Project: 08-25-3311 HCA LSMC CAMPUS EXPANSION
2100 SE BLUE PARKWAY
LEE'S SUMMIT, Missouri 64063

RFI #055: Civil - Pedestrian bridge elevated walk confirmation

INPATIENT BED EXPANSION

C5.1

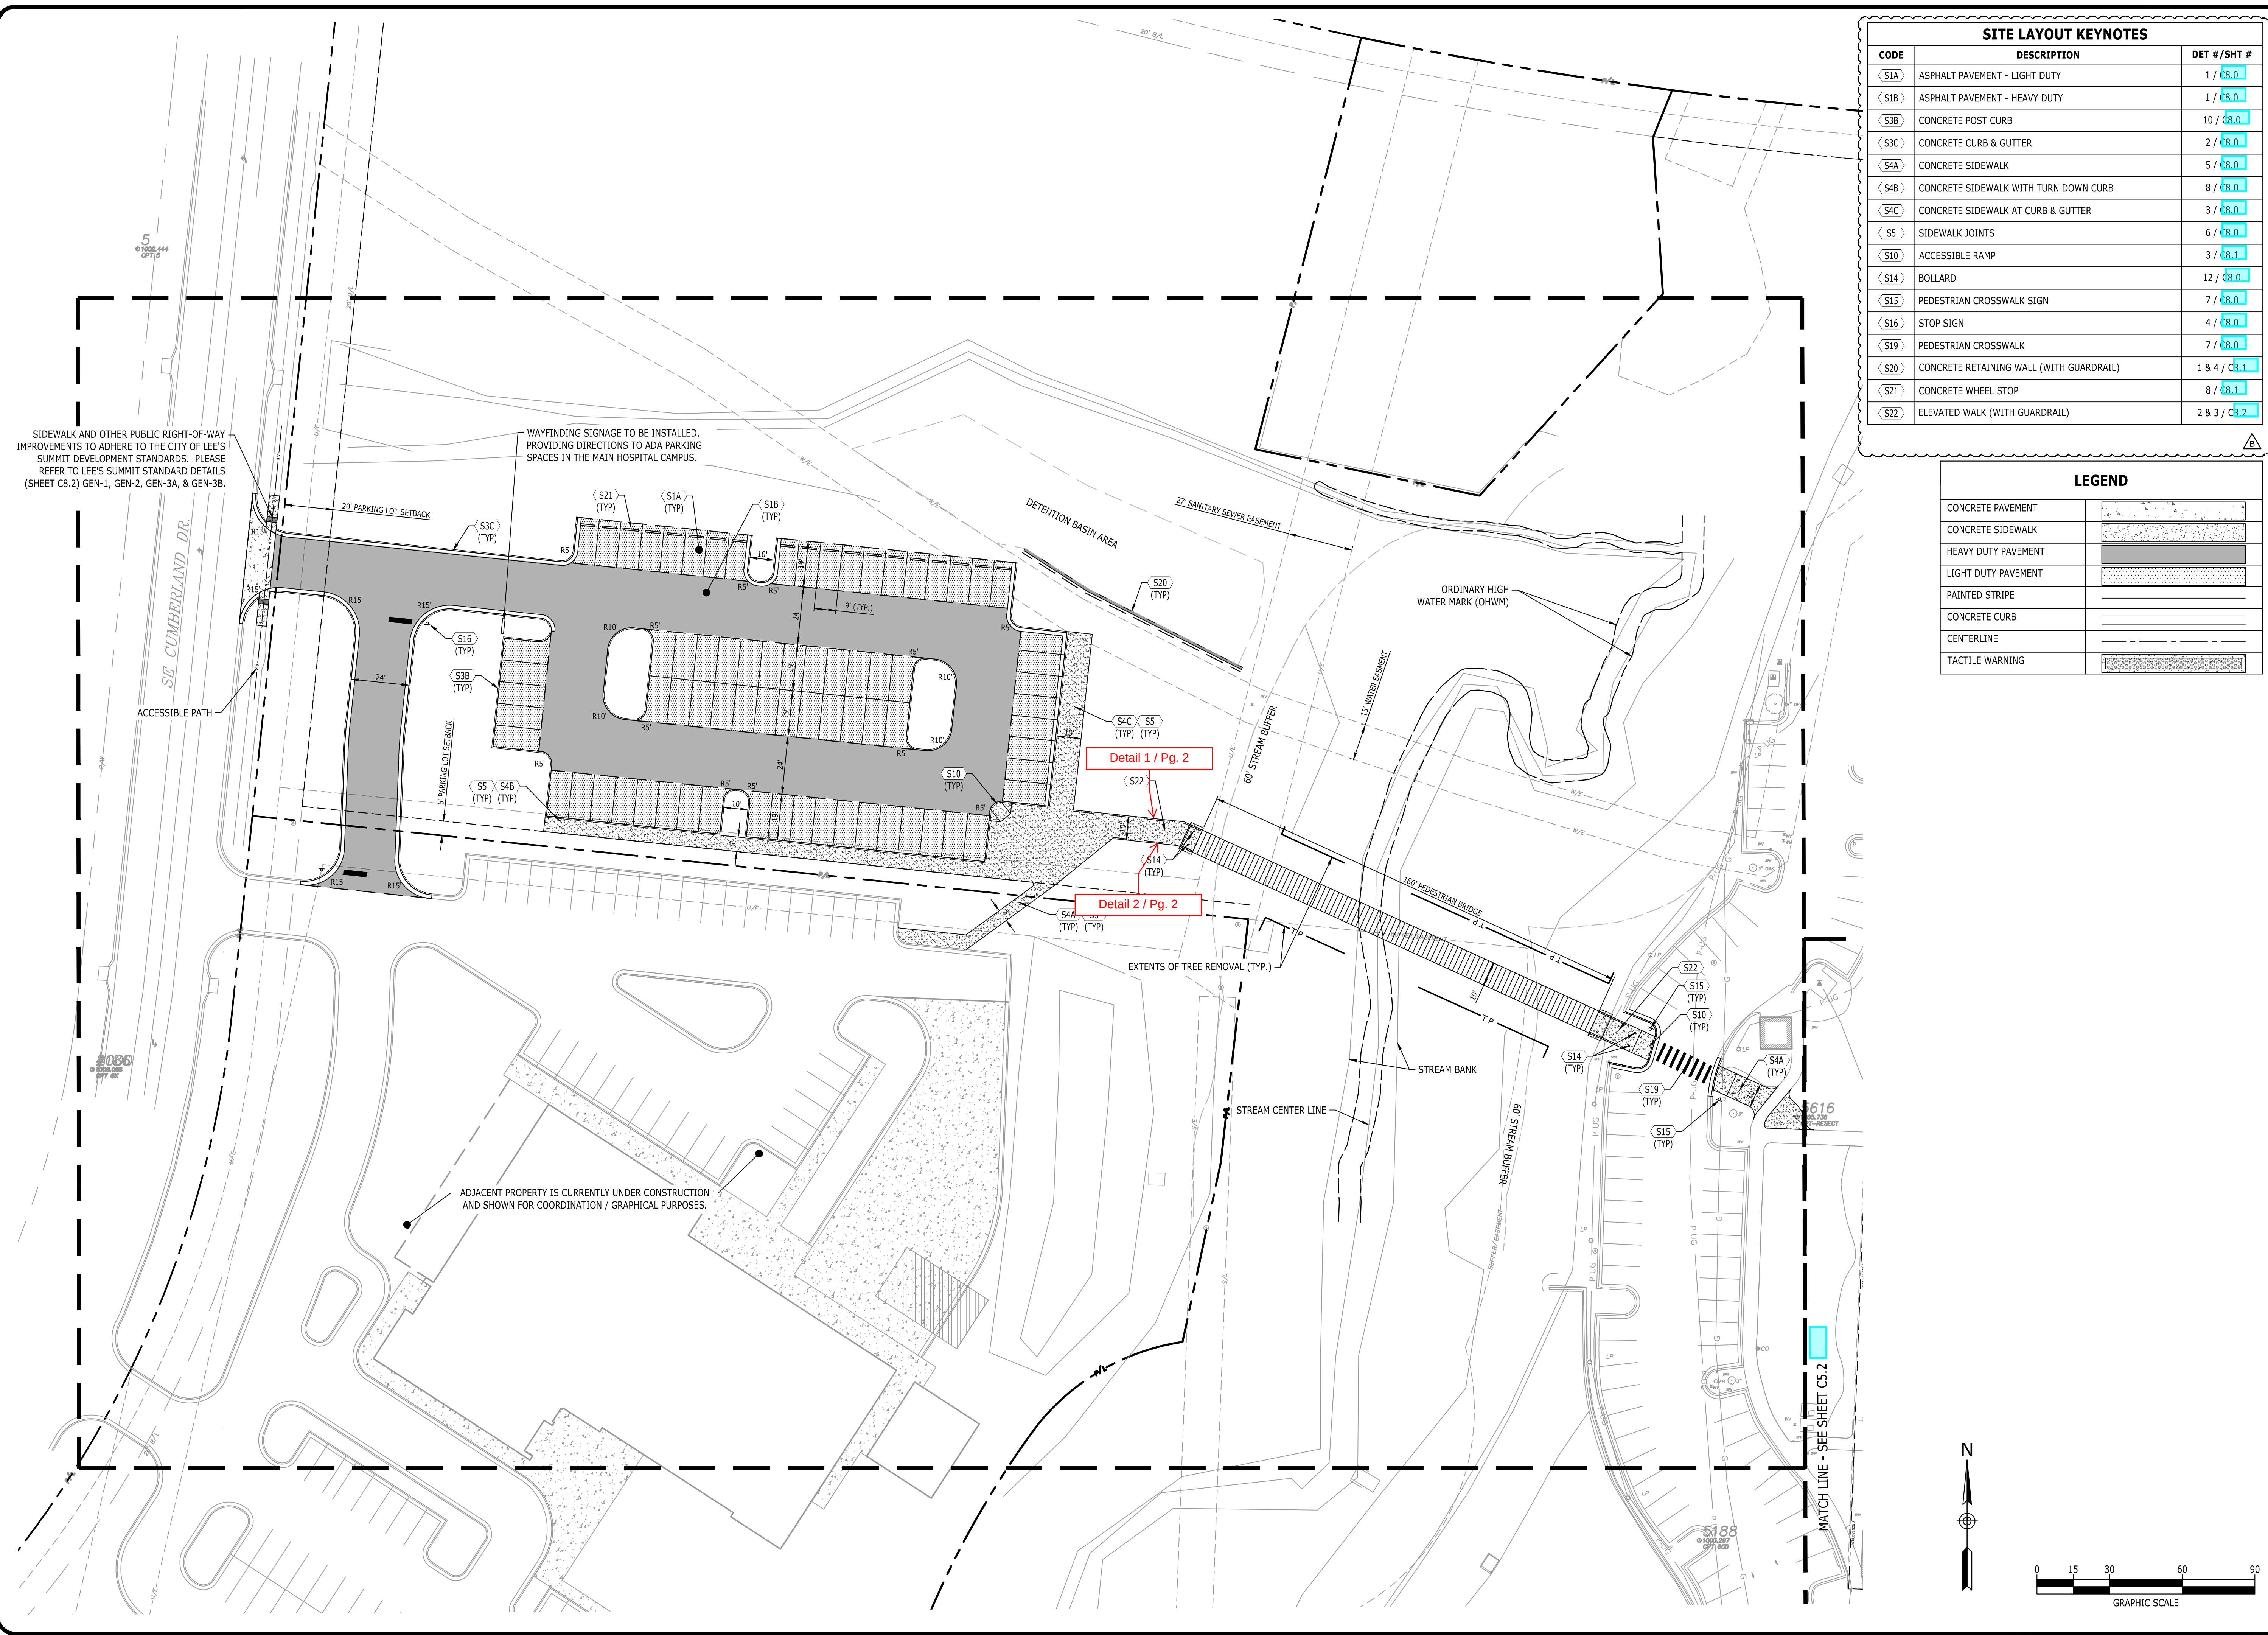
We made a drawing from our understanding of what the west side of the pedestrian elevated walk would look like following detail 3 on C8.2 (see attached). Please confirm if this is acceptable.

Due to the similar elevation from existing of the elevated walk on the east side, it is our understanding that we will be able to follow the turndown slab as shown on detail 3 on C8.2, so we did not create a drawing for this.

CDG Response: Refer to the mark up on the sketches, it appears the top of footers can be raised in some areas based on proposed finished grade and the details' parameters.

Detail 1

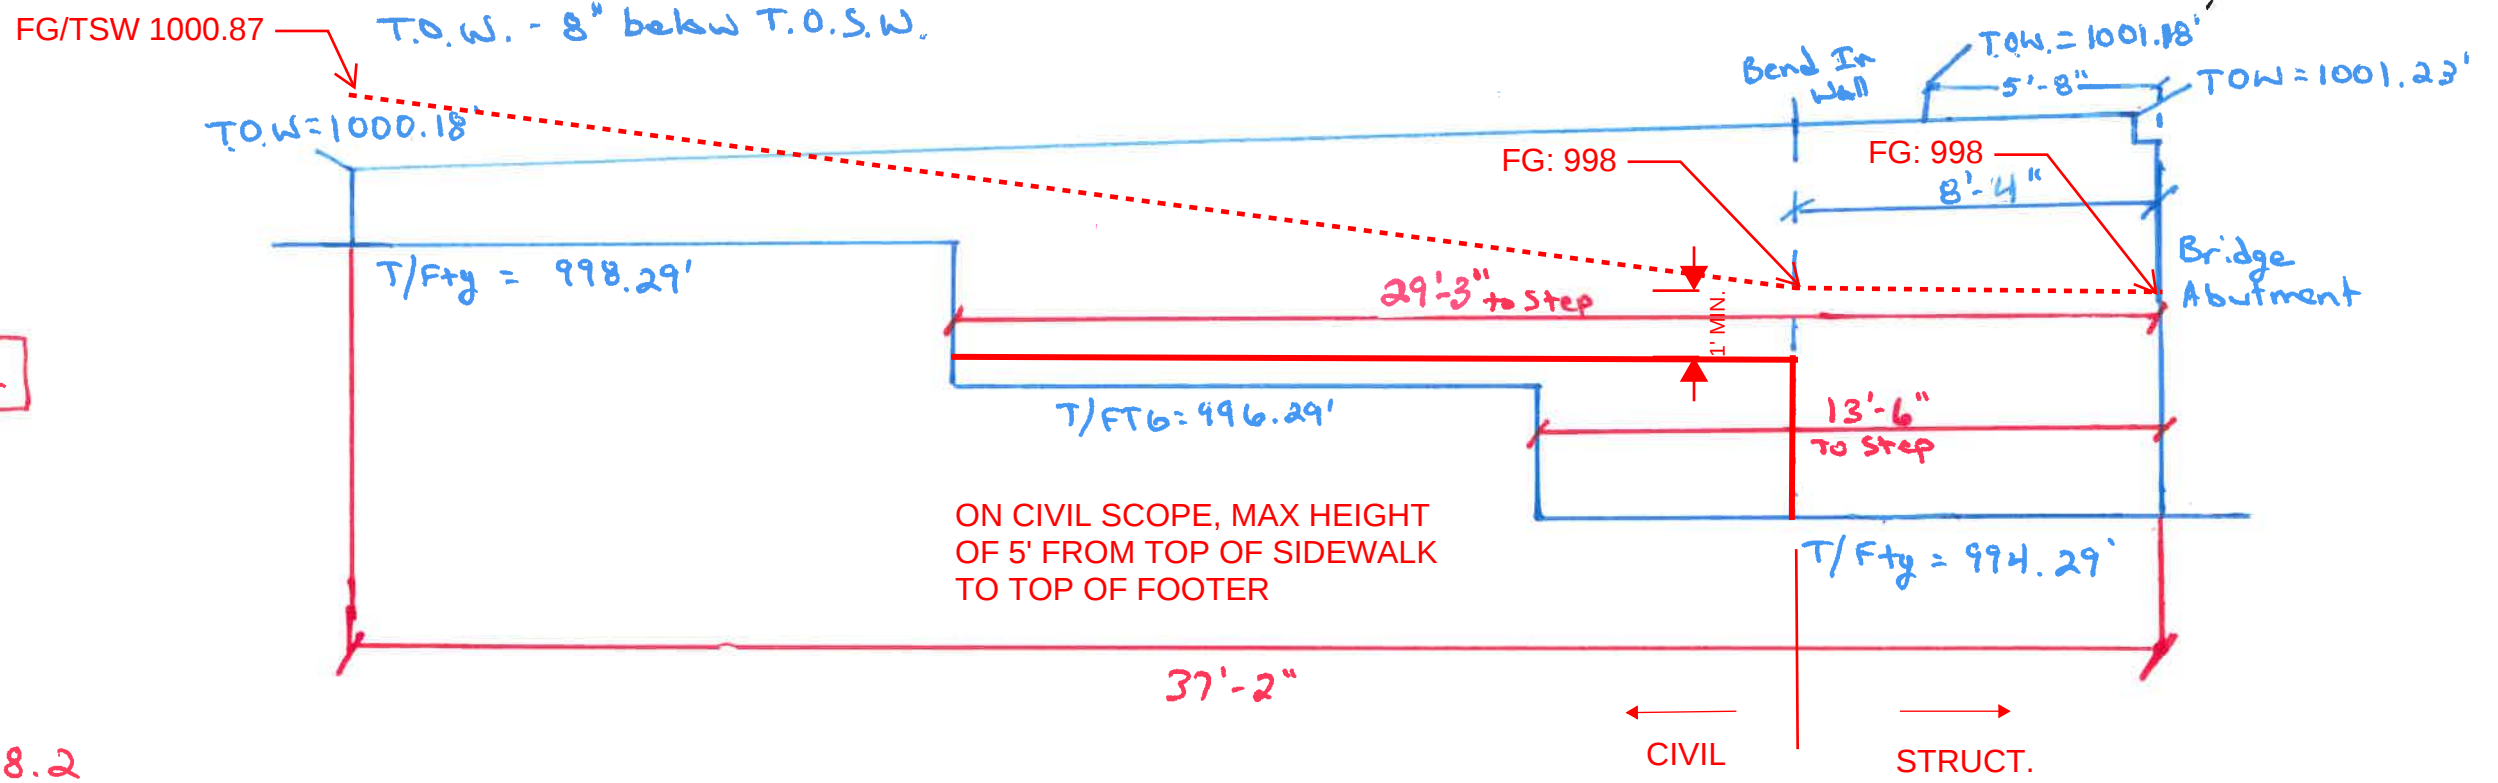
West Side of Bridge
North Side of Sidewalk

per detail 3 on pg. C8.2

Detail 2

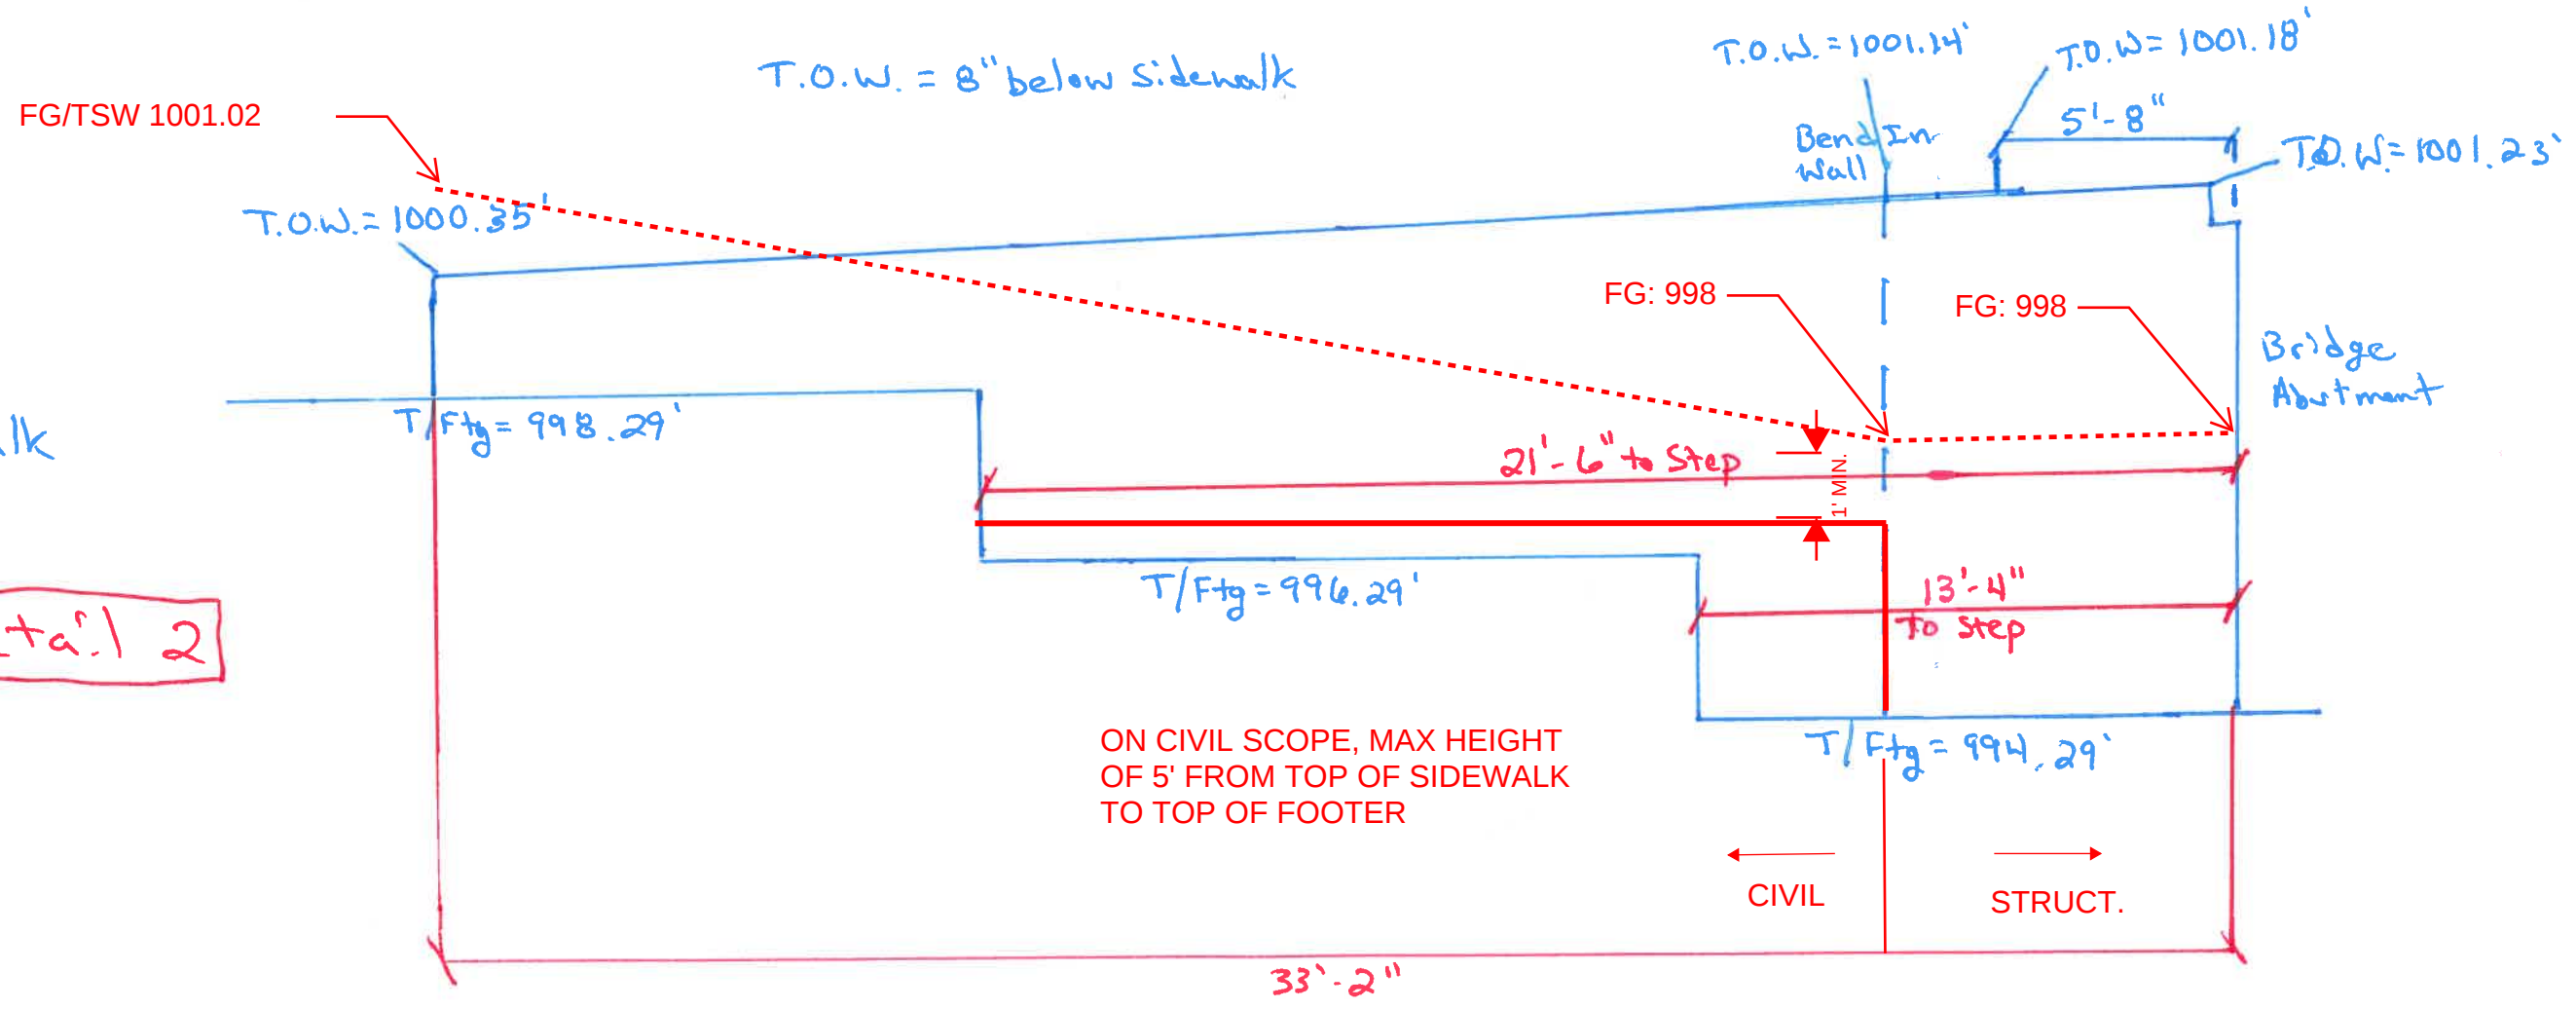
West Side of Bridge
South Side of Sidewalk
